S/UNI-TETRA REFERENCE DESIGN ERRATA

# S/UNI-TETRA REFERENCE DESIGN ISSUE 2.0

**ISSUE 2: JANUARY 1999**

PMC-981480

Figure 1 : Analog Power Filtering Recommendation

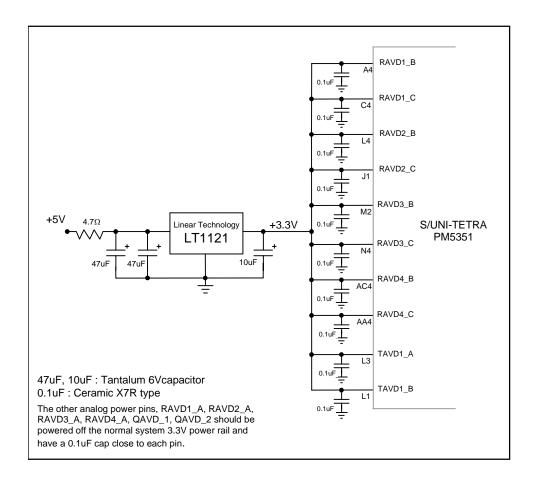
Issue: The Analog Power Filtering diagram shows the incorrect pin number (M4) for RAVD3\_B.

Fix: The correct pin number for RAVD3\_B should be M2.

Figure 2 : Correct BIAS pin connections for 5V Tolerant Operation

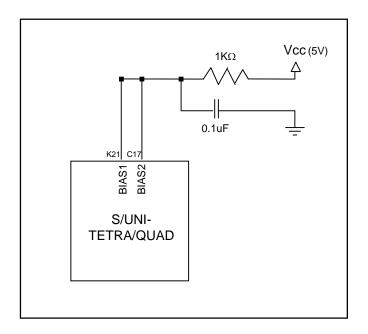
Issue: The schematics shows that 3.3V power supply is connected to the BIAS1, BIAS2 pins.

Fix: BIAS1, BIAS2 pins should be connected only to the Vcc (5V) through a 1K ohm resistor for 5V tolerant operation. The 3.3V should not be connected to the BIAS1, BIAS2 pins.
